工程指示 / 要求簡箋(E.I.)

工程指示編號：EI 13637 / 21

工程名稱：亞皆老街中電

工程項目：偏林箱 5,6/F 重出(銘化)

名稱	偏林箱	制圖	胡冬雲	2020.12.23	修改		
材料	3.0MM鋁板	復核			日期		
顏色	MILK 綠化	批准			圖號	T3A/W4, W5

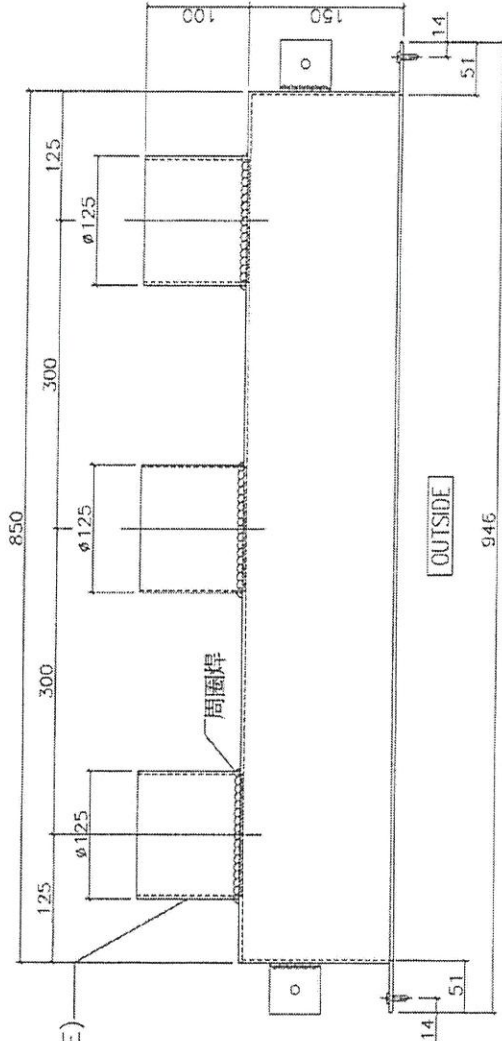
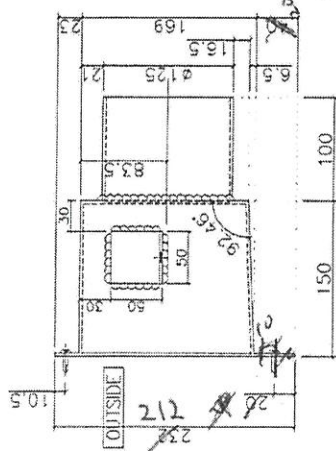
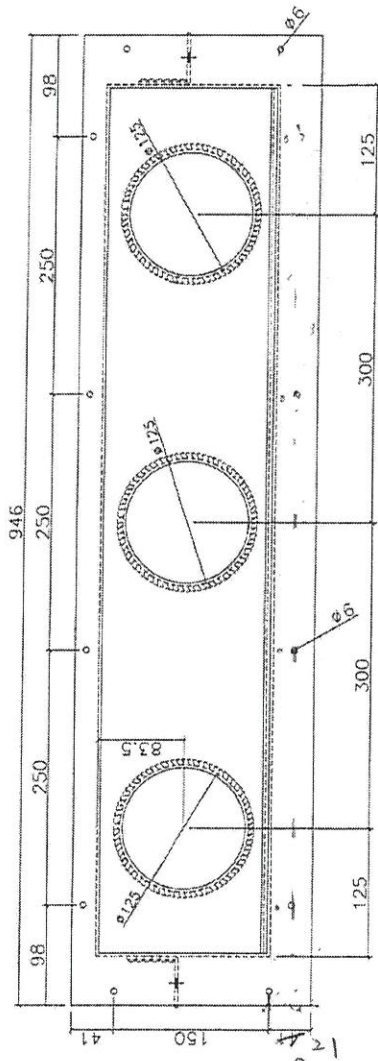
請按加工圖生產偏林箱送地盤更換

按顧問合約要求，所有 MILL 料需做銘化

T3, 5, 6/F 已裝 MILL 料偏林箱，需更換銘化箱
